HORSHAM DISTRICT COUNCIL CONSULTATION

TO:	Horsham District Council – Planning Dept
LOCATION:	Berkeley Homes Development Site Worthing Road Southwater RH13 9BT
DESCRIPTION:	Erection of 94 dwellings with associated access, parking and landscaping at Land West of Worthing Road (Phase 5), Southwater
REFERENCE:	DC/19/2464
RE-CONSULT:	1 st set of comments in black 2 nd set of comments in blue 3 rd set of comments in green 4 th set of comments in purple
RECOMMENDATION:	Modification / Advice
SUMMARY OF COMMENTS & RECOMMENDATION: 4th set of comments The majority of recommendations below could be secured through condition, however minor modification is requested in regard to layout and securing landscape strategy. We highlight in particular, points 5, 6, 9, 12, 13 and 14. 3rd set of comments See below 2nd set of comments See below 1st set of comments As discussed please see below a few bullet points on the main issues with the current layout for discussion. Please note I don't provide comments on the landscape plans submitted at this stage as there are issues with the layout, that will need to be agreed in first instance and landscape plans subsequently updated.

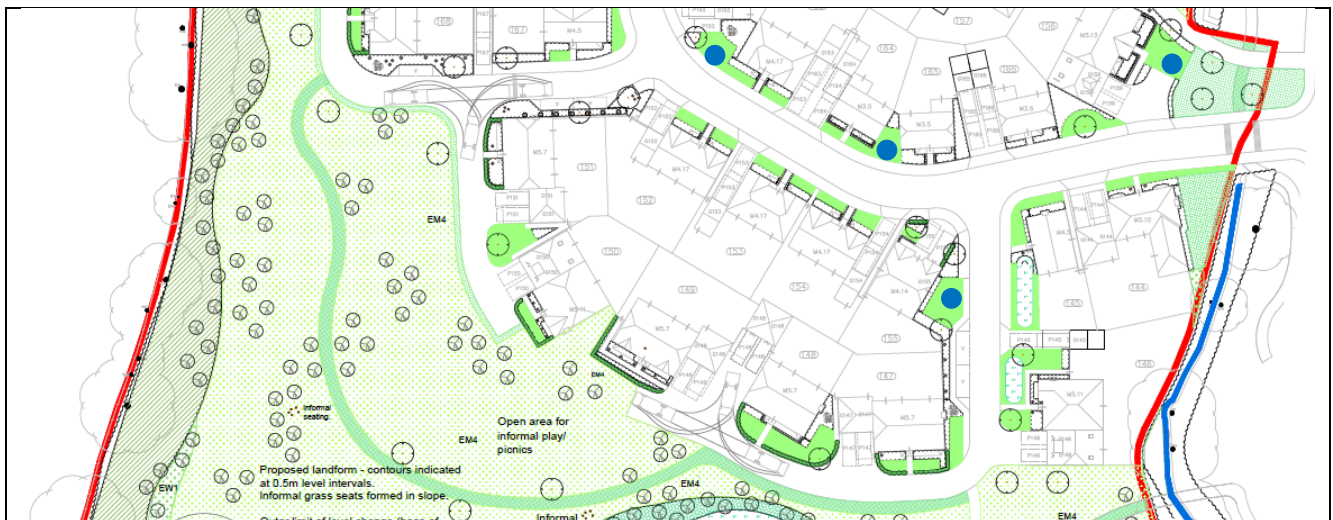
12. Additional mark-up trees suggested shown on the attached plan

Addressed in part, however the scheme has since been updated and trees relocated. Please see below [indicated in blue] a few more areas where we think tree planting could be accommodated. Service runs and utilities must be considered and coordinated with tree planting so that they are not lost later on in the process.

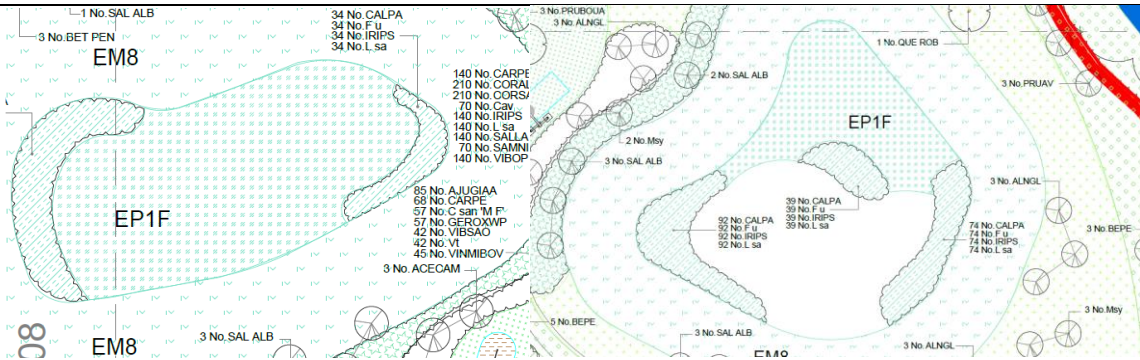
17. No interaction at all with ponds and recreation or play area. Opportunities such as a pond dipping or viewing platform, and flat areas for seating near the water must be explored.
Not addressed.
18. The current basin profiles are deep therefore they are likely to be requested to be fenced off by RoSPA and future residents, considering the proximity of the play area.
19. Please clarify the location of expected permanent levels of water within proposed ponds. As highlighted in point 16, drainage proposals have not yet been updated and appear to indicate the permanent water area within the basin as being located north of where SuDS planting is detailed. In addition, proposed levels must be updated to correlate with expected permanent levels of water.
20. Please add detail for the unlabelled area in white within the eastern pond [below right].
